SSD-8950984: Response to Submissions for the Burrendong Wind Farm Project

SSD-8950984: Response to Submissions for the Burrendong Wind Farm Project

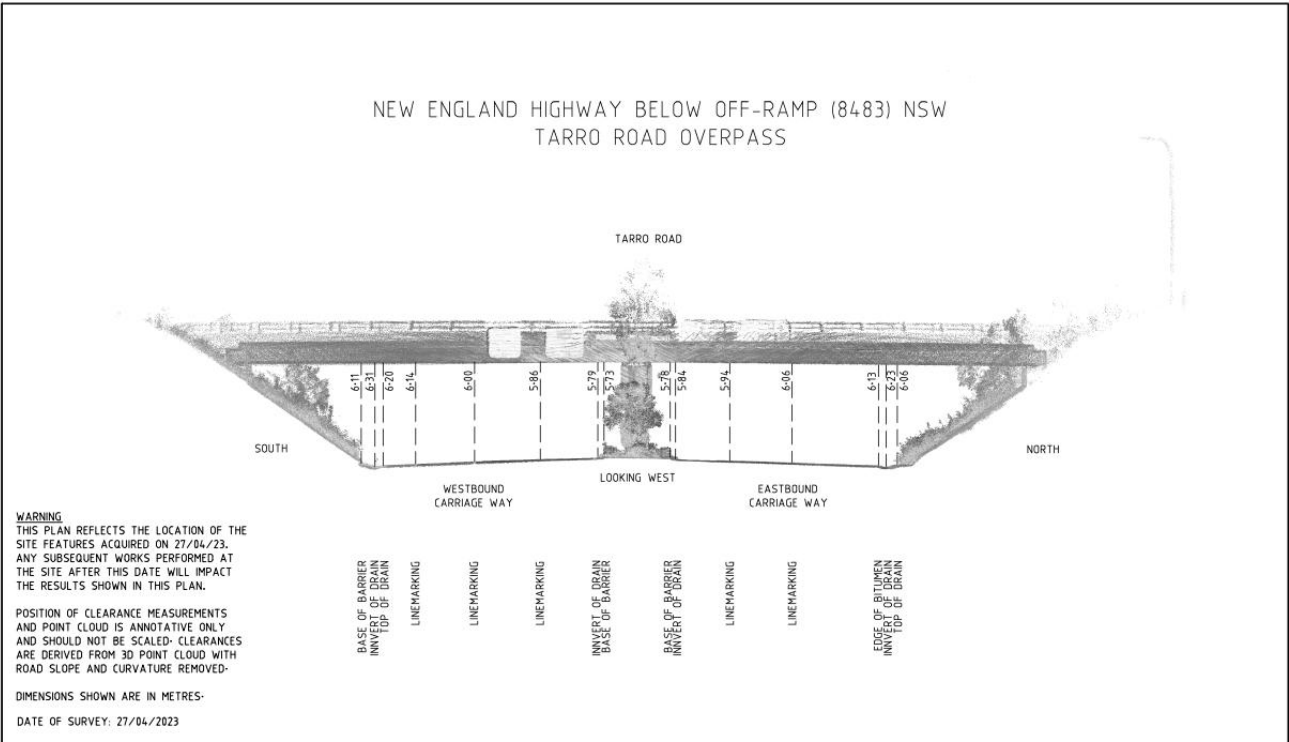
11.	Verge, batter, and table drain details must be included in all proposed strategic concept designs. It will be important to show how drainage will be managed at these intersections. Additional information is sought regarding the road formation and footprint. There are no shoulders or verges provided, nor any batters or table drains. Survey data will need to be collected to enable the designers to model all of this.
